**FINDINGS OF FACT
FLORENCE PLANNING COMMISSION
Exhibit "A"**

Application: PC 23 08 DR 02

Proposal: A Design Review application for a +/- 10,640 sq. ft. retail store on an undeveloped parcel located at the NE intersection of Highway 101 and 36th St., found on Assessor's Map #18-12-23-22, Tax Lot 06800. The proposal includes considerations of the store's exterior architecture, color pallet, parking, lighting, landscaping, pedestrian walkways, access, and utilities.

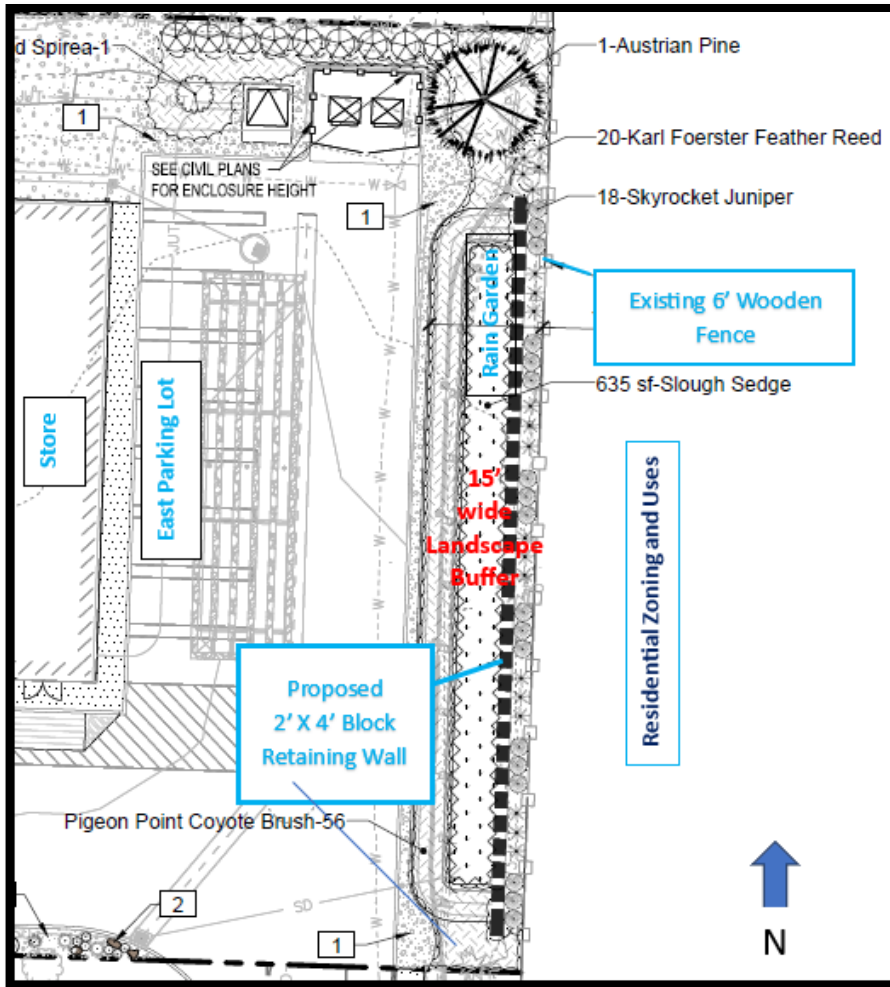
As discussed earlier, the applicant provided pre-existing conditions in Exhibit C. The Preliminary Grading and Stormwater Plan is located on Sheet CG-01 of the same exhibit. Given referral comments discussed in more detail under FCC 9-5 (Stormwater Management Requirements), the applicant has been conditioned under this Chapter to revise their stormwater plans to be compliant with the City's stormwater design manual and stormwater management plans. Generally, stormwater moving from the north to the south side will be conveyed from a series of catch basins to an at-grade infiltration rain garden. In the event of a 25 year, 24-hour storm event, only then will post-development stormwater be allowed into the public stormwater drainage system. Roof runoff and a portion of landscaping runoff north of the proposed building will be routed to a below-grade soakage trench, according to the current undated Stormwater Report in Exhibit H.

Although stormwater overflow is not anticipated on the sidewalks, the below condition of approval is given to stress this point.

Per FCC 10-3-8, parking areas shall be graded so as not to allow stormwater to drain over public sidewalks. [[Condition 4-2](#)]

West Elevation

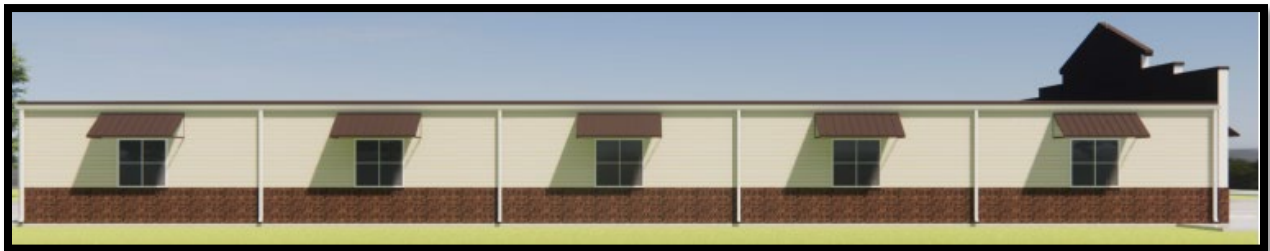
Sheets A2 - 5 of Exhibit D demonstrates several vertical breaks at every elevation. These vertical breaks include trim, canopies, windows:

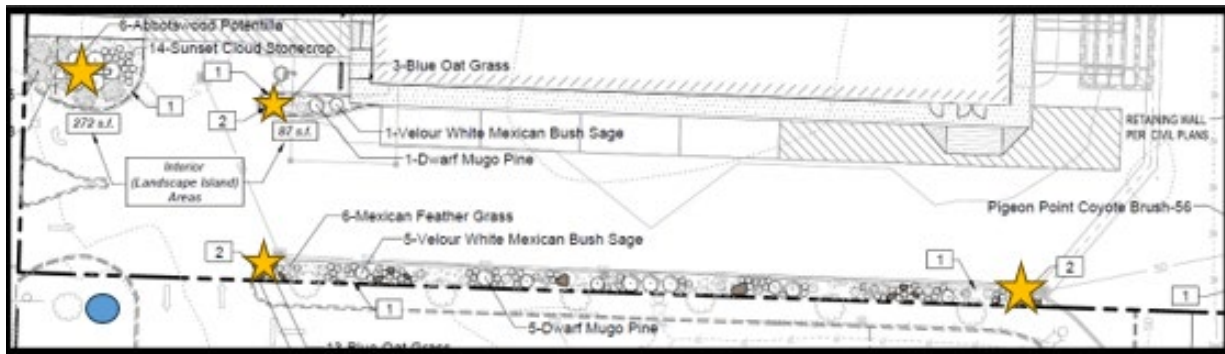
The image below shows the internal landscaped islands areas requiring vision clearance taken from Exhibit E, Sheet LS-01. Three vision clearance areas are marked with an orange star. The landscaped vision clearance on the Burger King site is marked with a blue circle:

Plantings within the south side property line strip include a mixture of Blue Oat Grass, Sunset Cloud Stonecrop, Mexican Feather Grass, Velour White Mexican Brush Sage, and Dwarf Mugo Pine. Materials include decorative rock mulch and landscape boulders. These latter rocks will be located at the ends of the strip island.

For those traveling westward to the west parking lot, and for the nearest ADA accessible van parking space, a landscape island will contain crushed decorative rock with two boulders, three Blue Oat Grass plants, one Velour White Mexican Bush Sage plant, and one Dwarf Mugo Pine. snowberry within 10' of the curb, and the mature size of the snowberry is stated as 3' to 4'. Similar landscaping is present at the intersection of the two-way driveway access to 35th Street and the internal parking lot area. In both cases, it requires a flexible interpretation of code to view these areas as potential violations of this code requirement. Even in that case, standard maintenance of the snowberry would relieve the issue.

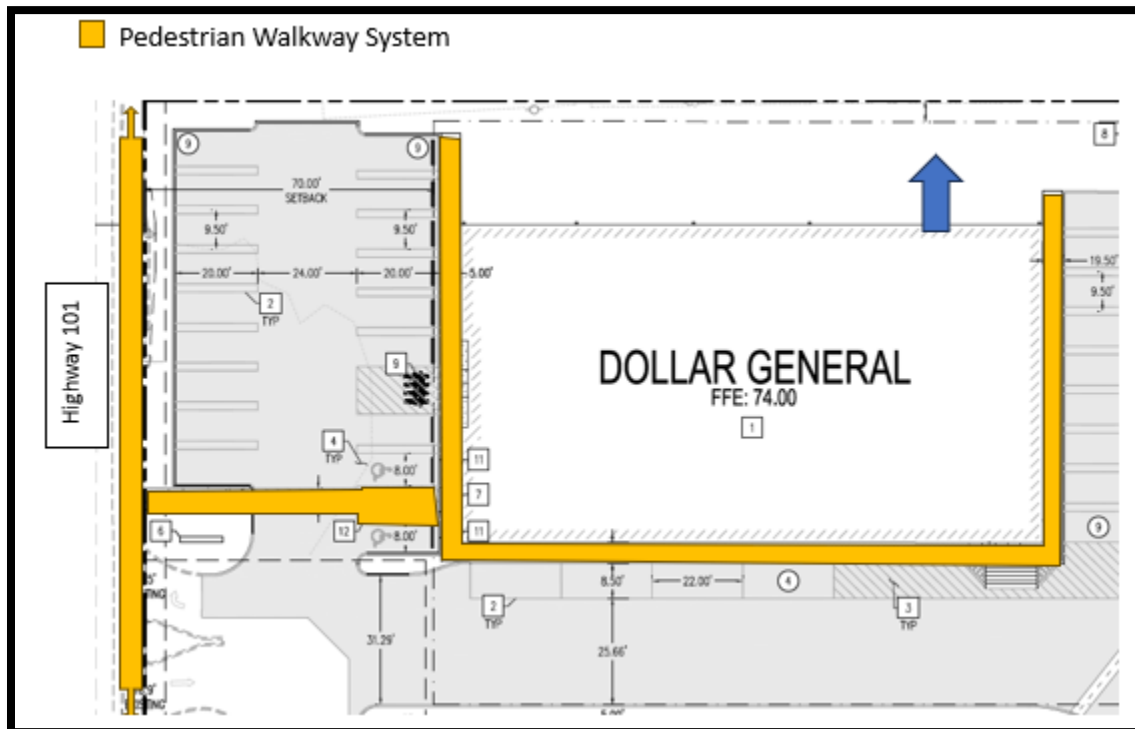
The applicant proposes to connect the Dollar General development to existing Burger King development to the south via the shared driveway from 35th Street as well as the shared Highway 101 access point. While connections between the lots for vehicle travel are addressed in the proposal, considerations for a continuous walkway system between the two uses may be gained through the use of the Highway 101 sidewalk.

The applicant has proposed a single 5'- wide pedestrian connection from the store to the public ROW along Highway 101. The proposed walkway does not extend throughout the development site and no future phases of the development are planned. Criterion met.
